SERVICE BULLETIN 151 — MANDATORY

SUBJECT: AN470A4-9 soft rivets

APPLICABILITY: Kits #2392, 2394, 3319 and 3320.

Figure 1

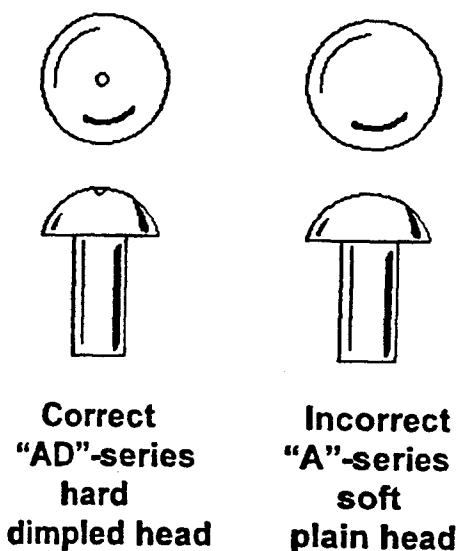
DISCUSSION: It has come to our attention that the supply of AN470AD4-9 universal-head rivets shipped with Glasair slotted flap kits and Glasair III complete kits between February 2 and February 24, 1998, was contaminated with a small quantity of AN470A4-9 rivets. These "A"-series rivets, which were inadvertently mixed in with the "AD"-series rivets by our vendor, are made of a much softer aluminum alloy than the "AD"-series rivets specified for the Glasair and therefore have insufficient strength. **They should not be used anywhere in the Glasair construction.**

REQUIRED ACTION: First, inspect your supply of AN470AD4-9 rivets and discard any soft, "A"-series rivets. They can be distinguished from the "AD"-series rivets by inspecting the rivet heads. As shown in Figure 1, the standard "AD"-series rivets have a small dimple in the center of the head, while the soft, "A"-series rivets have plain heads.

Second, inspect any completed work on your Glasair to see if any soft, "A"-series rivets were used. In all likelihood, you would have discovered the "A"-series rivets while squeezing them, because they are so much softer than "AD"-series rivets that they squeeze with a distinctly different, softer feel. If you discover any soft rivets, you must drill them out and replace them with proper AN470AD4-9 rivets. If necessary, refer to "FABRICATION TECHNIQUES" in the *Glasair Instruction Manual* to refresh your memory on the proper procedure for replacing defective rivets.

If you run short of AN470AD4-9 rivets as a result of culling soft, "A"-series rivets from your stock, please contact Stoddard-Hamilton Option Sales for replacements. However, we customarily send a few more rivets of each size than specified, so you may find you have enough extra already on hand. If you need replacement rivets, please contact Stoddard-Hamilton by **no later than March 15, 1998**, to receive them at no charge.
